By letter dated January 12, 2009, Electric Power Research Institute (EPRI) submitted for U.S. Nuclear Regulatory Commission (NRC) staff review Topical Report (TR) 1006596, "Materials Reliability Program (MRP): Pressurized Water Reactor Internals Inspection and Evaluation Guidelines." Upon review of the information provided, the NRC staff has determined that additional information (RAI) is needed to capture the initial set of technical questions related to the NRC staff's review of TR MRP-227 to support completion of the review. The NRC staff will however issue another set of RAIs based on its review of the MRP-227 report and its supporting reports. By e-mail dated September 22, 2009, Anne Deema, Senior Project Manager, and I agreed that the NRC staff will receive your response to the enclosed RAI questions within 30 days of issuance of this letter.

RAI 3-2 TR MRP-227, Rev. 0, does not make reference to Nuclear Energy Institute (NEI) Report No. NEI 95-10, Revision 6,² 2 as an applicable industry license renewal report; nor does TR MRP-227, Rev. 0, provide any discussion on how it will be used to conform to the recommendations in NEI 95-10, Rev. 6, when implementation of the I&E rec

Figure 2.1 from MRP-227

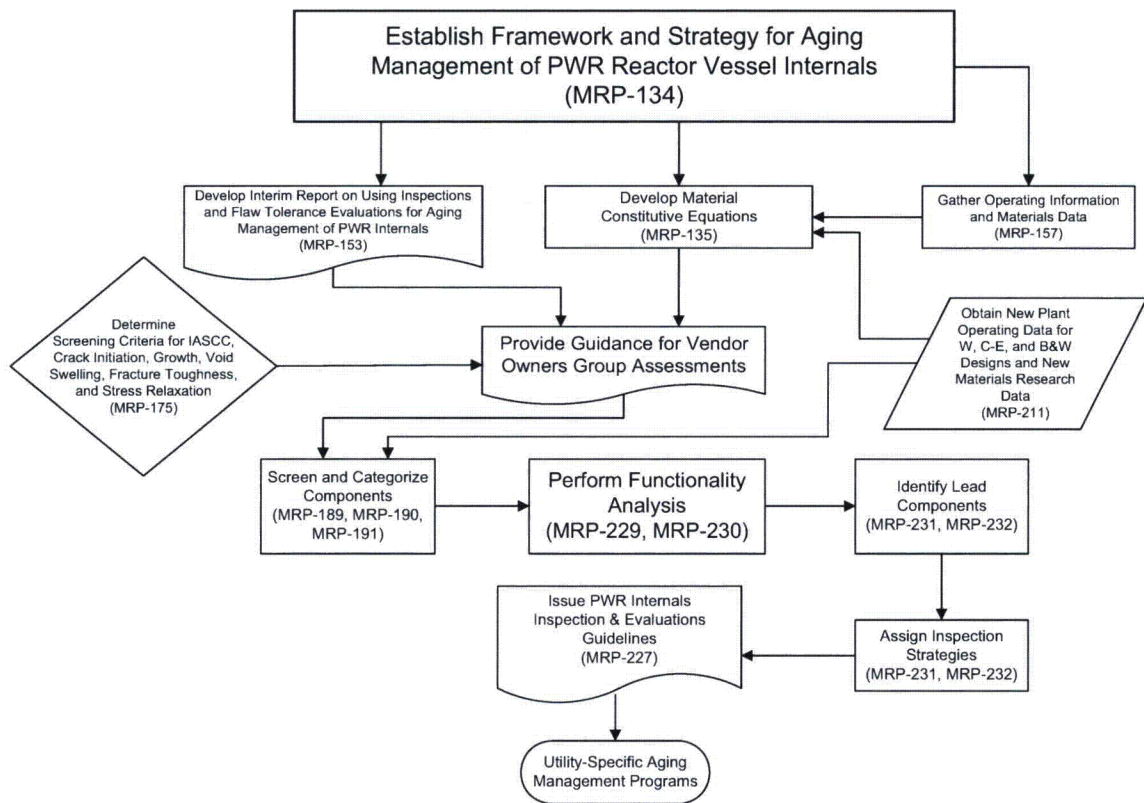
MRP-227, Revision 0 summarizes the results of industry programs for investigating and managing these aging effects in reactor internals and provides recommendations for the implementation of those results. A graphical representation of the process is depicted in MRP-227, Revision 0 Figure 2-1. The MRP-227, Revision 0 methodology begins with an extensive effort to identify materials, environment, stresses, service conditions, operating experience and other relevant information as required by SRP-LR BTP RLSB-1. This initial effort is described in MRP-134, MRP-135, MRP-153, MRP-157 and MRP-211. The second step in the process defines screening criteria that can be used to identify conditions that can potentially result in component degradation. Screening criteria were developed for eight relevant degradation mechanisms. These relevant degradation modes included the mechanisms identified in the GALL as “AMR Results for Which Further Evaluation is Recommended.” Each component was compared to the MRP-175 screening criteria to identify applicable aging effects. The results of the screening process are reported in MRP-189, Revision 1 and MRP-191. This screening process is integral to the AMR and should not be confused with the screening process used to identify passive components per 10 CFR Part 54.21(a)(1).
